New Product Information

Bearing for Connecting Rod (4A-G 20 Valve)

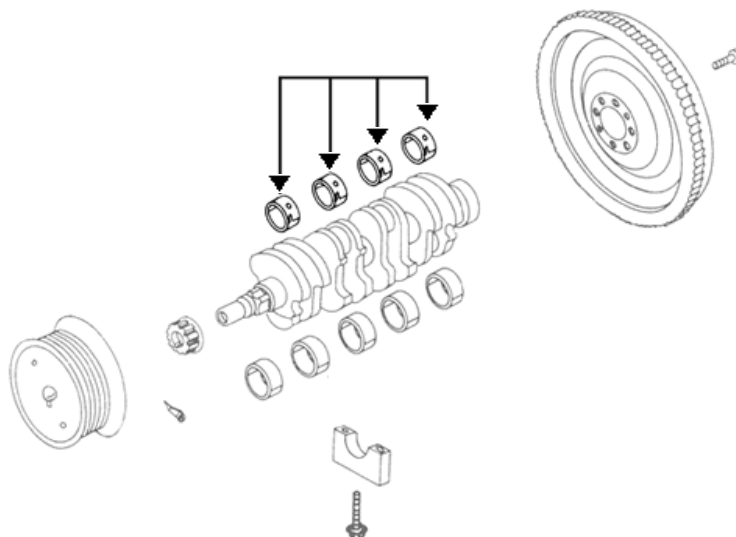
- THEY USED FOR THE RACE ENGINES AND HAS ADOPTED A NEW MATERIAL THAT CORRESPONDS TO THE HIGH SURFACE PRESSURE HIGH PERIPHERAL SPEED.
- THIS CONNECTING ROD BEARING CAN BE USED FOR RACE ENGINES ALSO.
